INDESIT company

Model type:
LV65ABK

Commercial code:
F026627

Notices

n1045034: New top condenser.

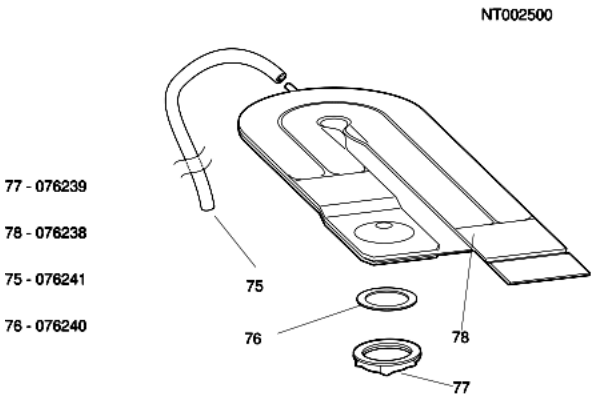
As of the last week in July 2000, the new "Wind drying system" was inserted on some appliances from the new MarckII Range.
This new system foresees the elimination of the lateral air-flow body and the insertion of a new system with top condenser.
The spare part numbers eliminated are as follows:

054927(Rohs 144335) - RING NUT FOR AIR-FLOW BODY
054928 - AIR-FLOW BODY
103689 - NOZZLE GASKET
057874 - TOP SOUNDPROOFING LAYER

076238 - WIND DRYNG SYSTEM CONDENSER
076239 - CONDENSER RING NUT
076240 - TOP CONDENSER GASKET
076241 - TOP CONDENSER PIPE

The new part numbers are not interchangeable with the old ones, as they are completely different. See technical drawing attached to notice NT002500.

Photo N1045062FIG1 illustrates the bottom of the dishwasher with EVO structure.

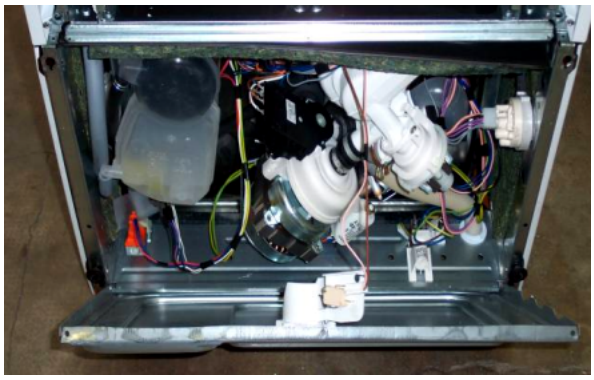
From serial number 30101.0001, all dishwasher models affected by this modification have been produced with EVO structure.
These models have been equipped with NEW TRAYS AND NEW FEET (see N1045062TAB1).

Regulation assembly DX/SX Sat codes 078397 and 078396 will be managed up to stock end, after that they will be replaced by new Sat codes 092821 and092820. The same is for rear foot Sat code 078385 which will be replaced by Sat code 092822.

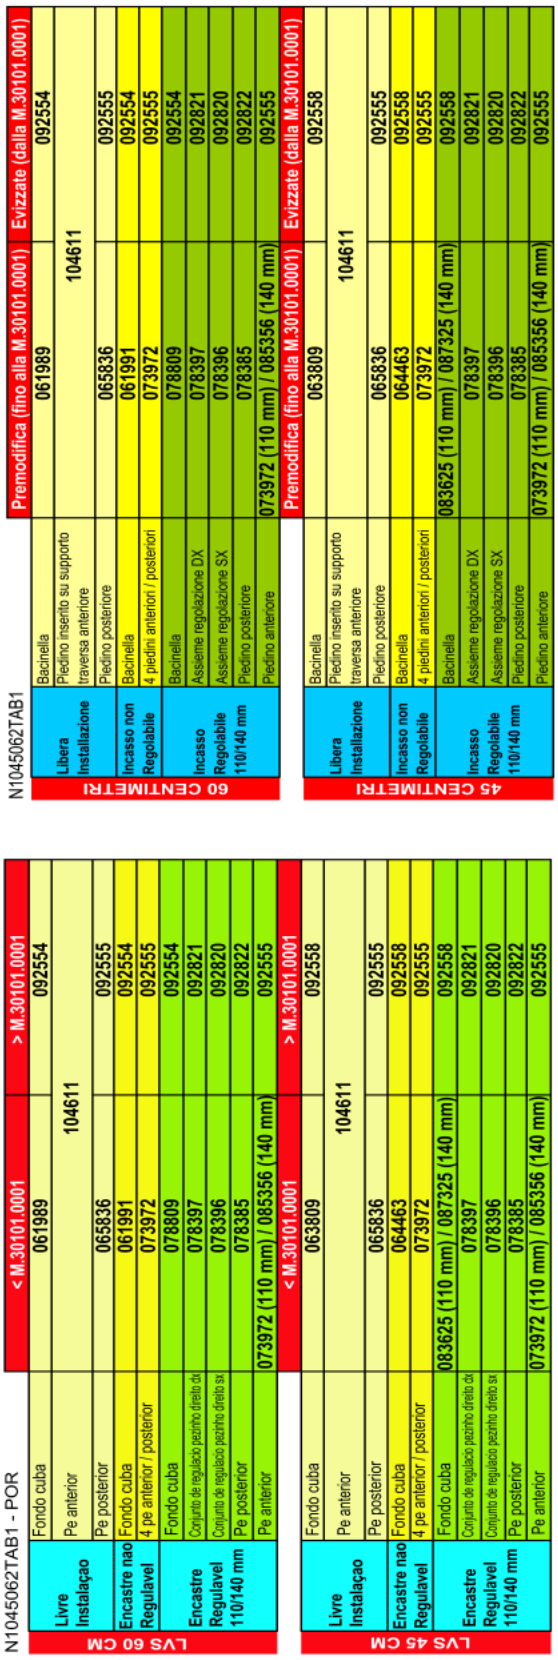
PREMODIFICATION:
Tray: 083625 (for commercial code 28490) 078809 (for commercial codes 26043-23520-28088);
Tray rear feet: 078396-078397-078385;
Tray front feet: 073972;
Front feet supports: 065836(Rohs 143584);
Feet supplied with plinth accessories assembly: 034261;

EVO STRUCTURE:
Tray: 092558 (for commercial code 28490) 092554 (for commercial code 26043-23520-28088);
Tray rear feet: 092820-092821-092822;
Tray front feet: 092555;
Front feet supports: 065836;
Feet supplied with plinth accessories assembly: 034261.

N1045063

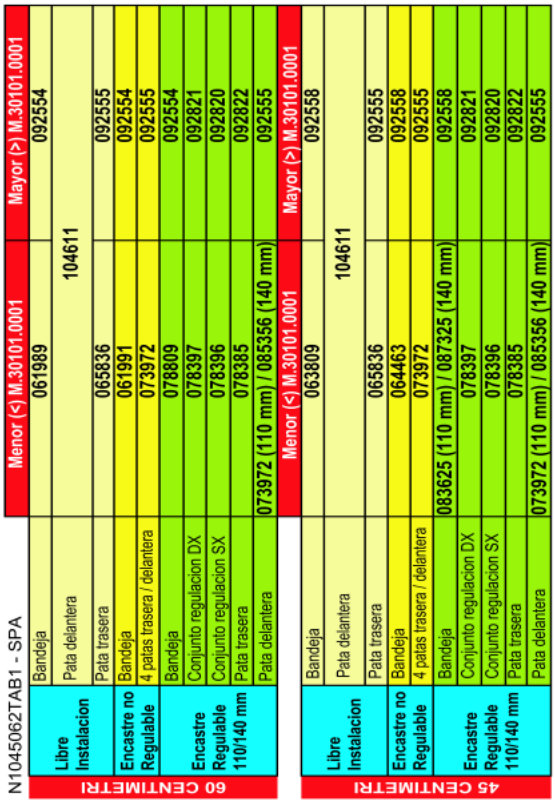
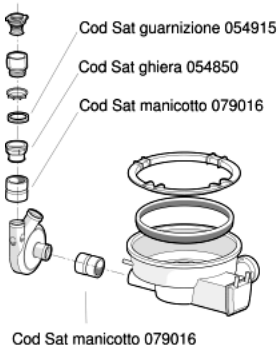
From serial number 30224.0001, all dishwashers affected by this modification have been equipped with the new coupling+ring nut assembly Sat code 093752, in place of coupling Sat code 079016, ring nut Sat code 054850 and gasket Sat code 054915.

Ring nut Sat code 054850 will continue to be available from the spare parts warehouse while stocks last, and coupling Sat code 079016 will continue to be stocked because it is still used for the tank-volute connection.
Picture N1045063 illustrates the premodification structure in FIG1 and the new structure in FIG2.

N1045081FIG1

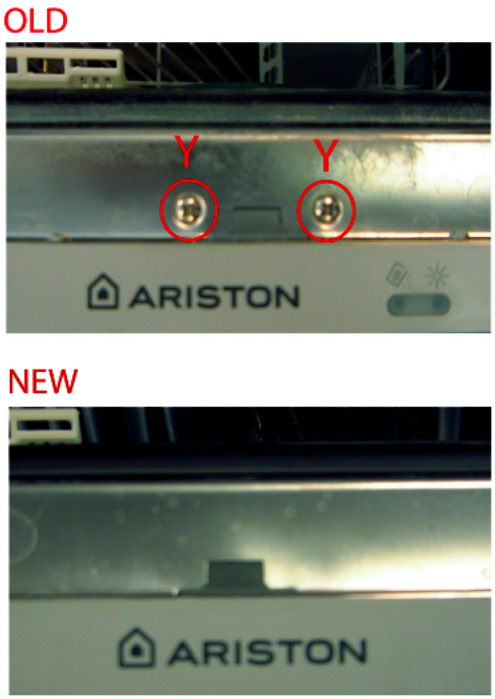
From serial no. 40614.0001, all 60 cm dishwashers affected by this note have been equipped with the locking unit code 094128 in place of 085357.
Following the elimination of the two screws Y (see N1045081FIG1) used to fix the locking unit on the inside door, the locking

unit and inside door were also modified, which can be mounted on premodification appliances by replacing the premodification locking unit with the new one.

Codes of modified inside doors:
085023 PREMODIFICATION - 112451 NEW
